IEC/IEEE 60802

IA-station Model

V01 – November 2021

IA-controllers and IA-devices in IA-stations

60802 D1.3 IA-station model

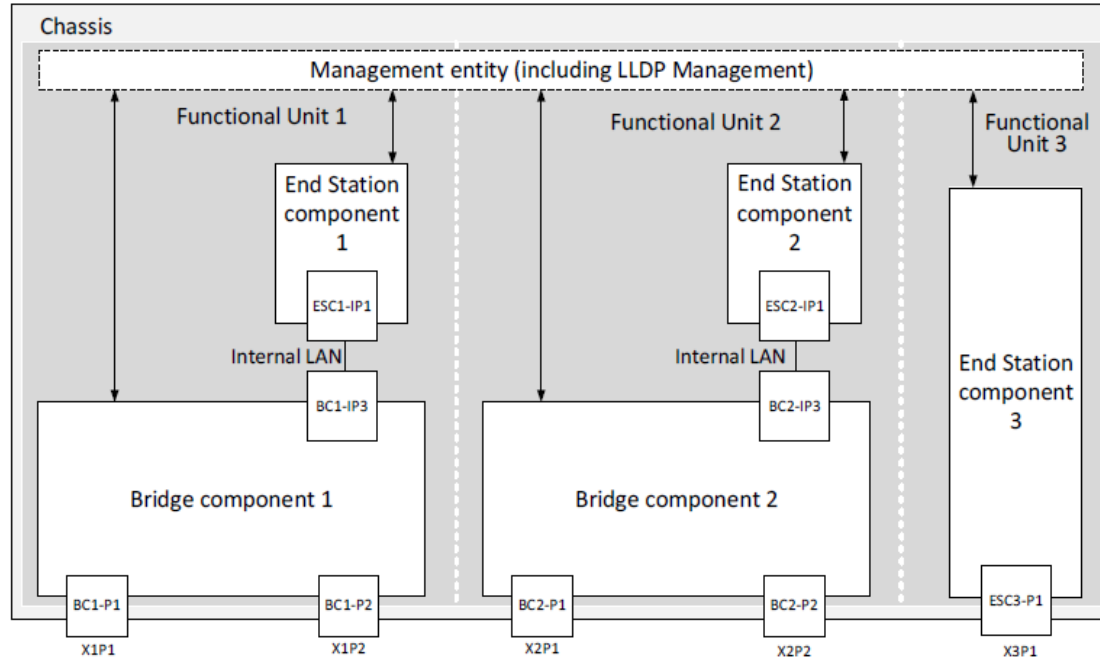
- The relation between IA-stations and IA-controllers / IA-devices is not described in D1.3 – only a Note indicates:
Note 1 to entry: IA-controllers and IA-devices contain an IA-station
- The IA-station example in D1.3 (Figure 2) shows only a management view - without any IA-controller / IA-device instance.

→ This led to confusion and discussions!

See D1.3 comments #127 and #140:

the relationship between **IA-stations** and **IA-controllers / IA-devices** should be described

Management in IA-stations

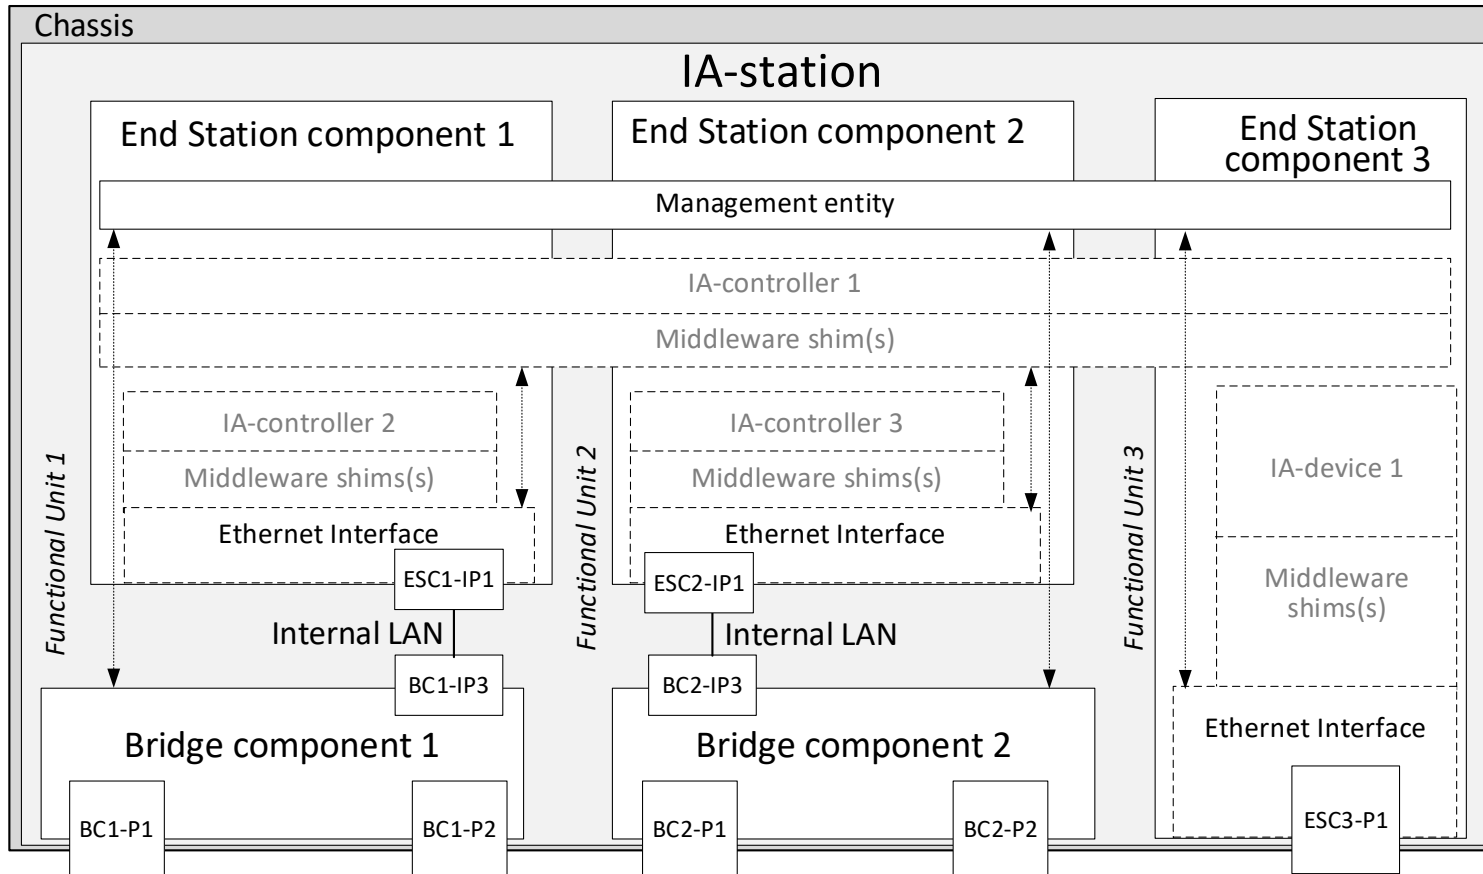
- Management entity acts as “*a source of, and/or destination for, link layer data traffic carried on the network*” (see IEEE 802-2014).
 - **Management entity is an end station.**

Proposal for enhanced Figure 2 (aligned to Figure 3 – Industrial Application)

- IA-station applications can
 - be assigned to a single end station component, or
 - encompass multiple end station components.
- Management entity is an IA-station application encompassing all end station components.
- IA-controller/-device and middleware shim(s) are out-of-scope for IEC/IEEE 60802.
